APPENDIX A:

Facility Reports

City Hall - Exterior
2600 Fresno Street, Fresno

34 - 1 Fixed Bench

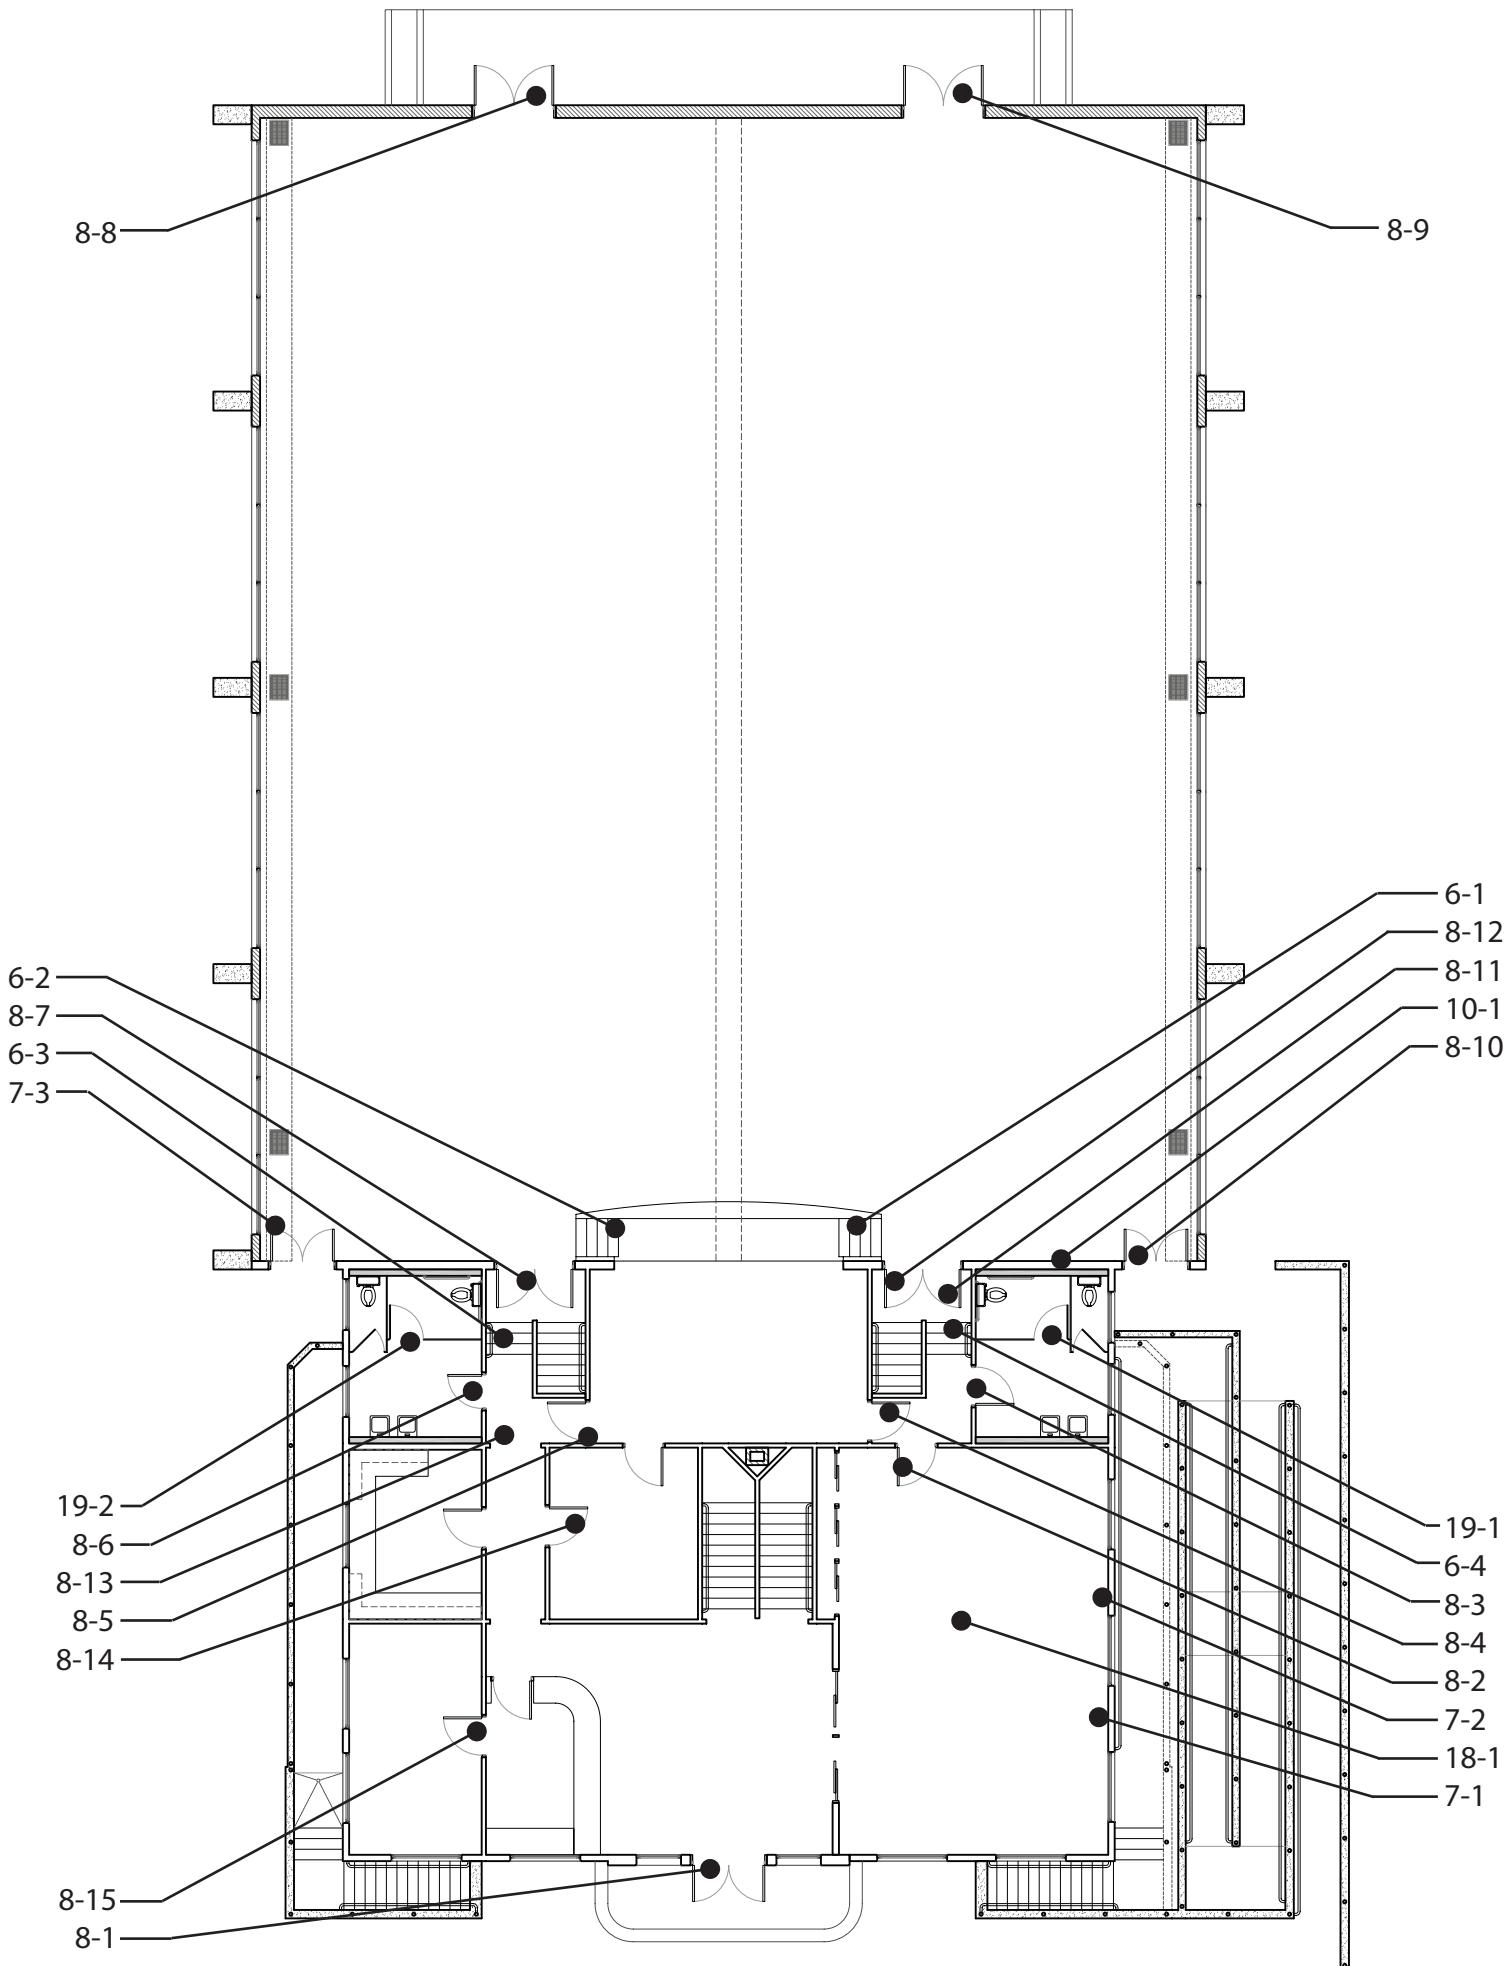
Provide accessible fixed bench

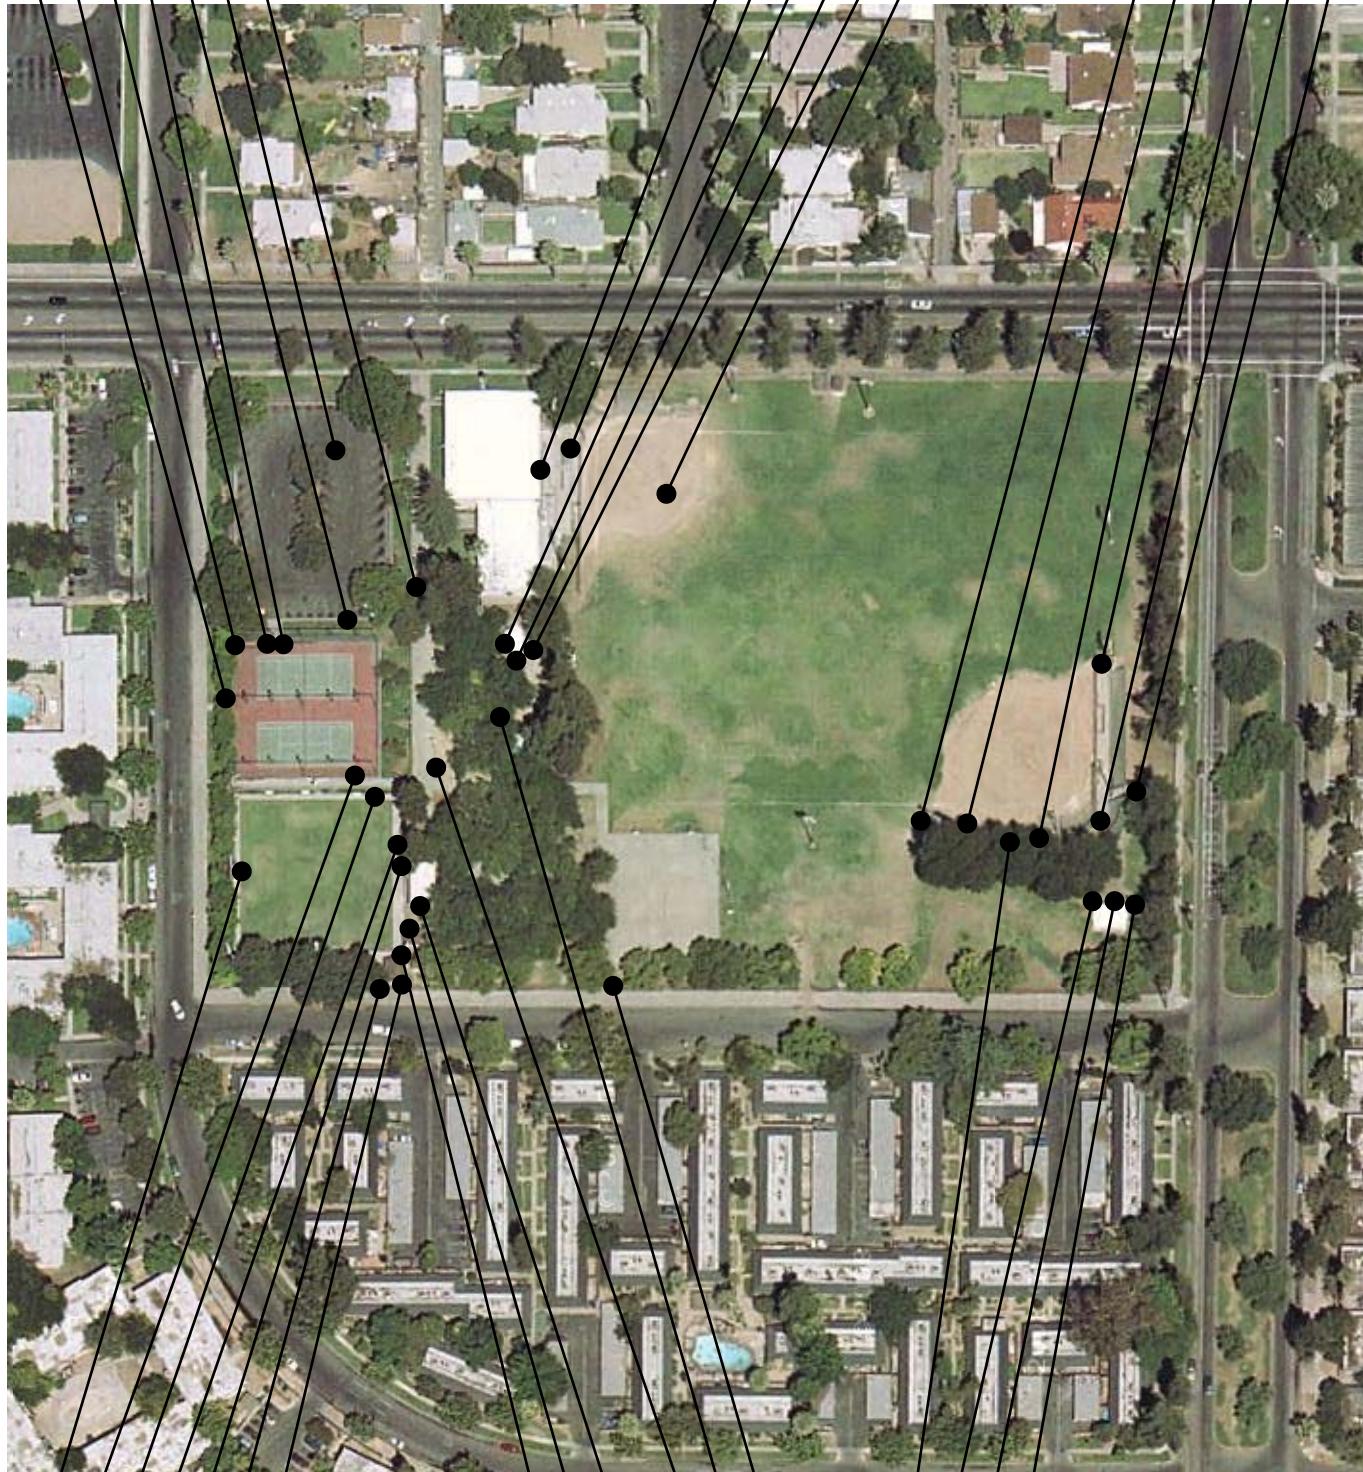
Exterior	
4 - 1	Walk
	Priority: 4
Replace or reorient grate	\$2,000
Notes: There are 8 gratings in the lawn bowling court that are 10" in diameter and 5-1/2" deep.	
State: 1124B.4, 1133B.7.2	
Federal: 4.5.4	
4 - 2	Walk
	Priority: 2
Regrade surface	\$2,520
Notes: Cross slope ranges from 2.5% to 4.6% (2% max) for a distance of 63'9".	
State: 1133B.7.1.3	
Federal: 4.3.7	
4 - 3	Walk
	Priority: 2
Regrade surface	\$120
Notes: Cross slope ranges from 2.1% to 2.9% (2% max) for a distance of 3'.	
State: 1133B.7.1.3	
Federal: 4.3.7	
4 - 4	Walk
	Priority: 2
Repair surface	\$250
Notes: At the basketball courts, there is cracked pavement that is 6" x 3". There is also a 1" (1/4" max) change in surface level for a distance of 13'10".	
State: 1133B.7.4	
Federal: 4.5.2	
4 - 5	Walk
	Priority: 2
Regrade surface	\$360
Notes: Cross slope ranges from 2.1% to 2.3% (2% max) for a distance of 8'9".	
State: 1133B.7.1.3	
Federal: 4.3.7

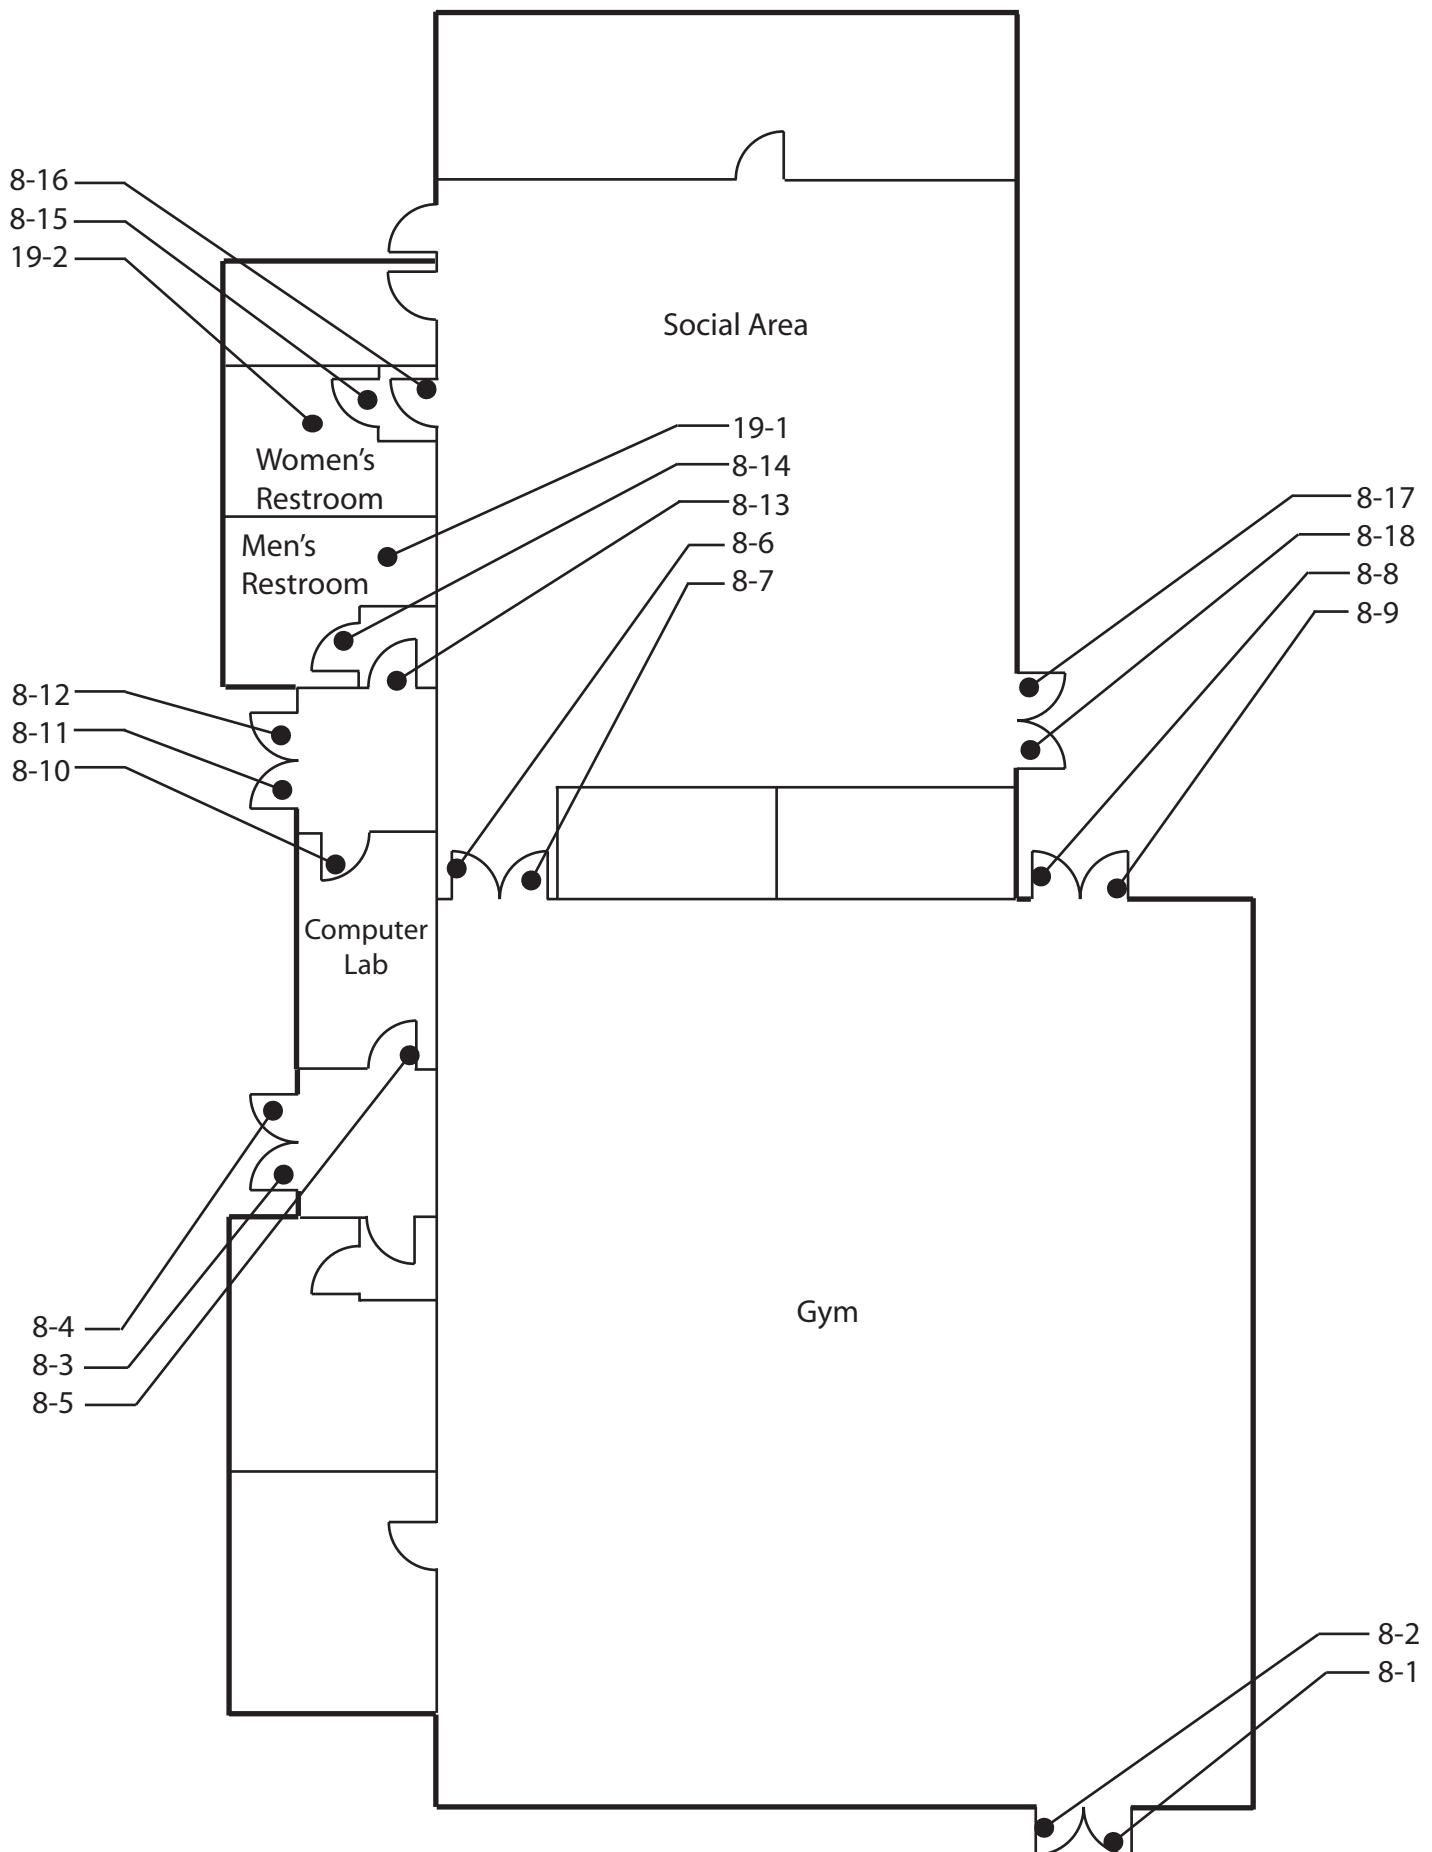
30 - 2	Grandstand/Bleacher (interior or exterior)	Priority:2
Provide accessible seating		\$1,500
Notes:	There are 2 bleachers. Accessible seating is not provided at the bleachers.	
State:	1104B.3.4.1, 1104B.3.5, 1104B.3.6	
Federal:	4.1.3(19)(a), 4.33.3	
31 - 1	Swimming Pool / Wading Pools / Spas (int. or ext.)	Priority:4
Provide an accessible method for entering the pool		\$3,500
Notes:	The wading pool does not provide a ramp as access.	
State:	1133B.5.5.1	
Federal:	15.8.6.2	
32 - 1	Picnic Area	Priority:4
Modify operating mechanism		\$2,000
Notes:	Control requires two hands to operate.	
State:	-	
Federal:	308	
Regrade surface		\$800
Notes:	Slope in front of the cooking grill is 3.4% (2% max). Surface is dirt, therefore it is not a stable surface.	
State:	-	
Federal:	308	
32 - 2	Picnic Area	Priority:4
Modify operating mechanism		\$2,000
Notes:	Grill control requires two hands.	
State:	-	
Federal:	308	
34 - 1	Fixed Bench	Priority:4

Provide accessible fixed bench		\$900
Notes:	There are 14 benches. Armrests are not provided for any of the benches.	
State:	-	
Federal:	-
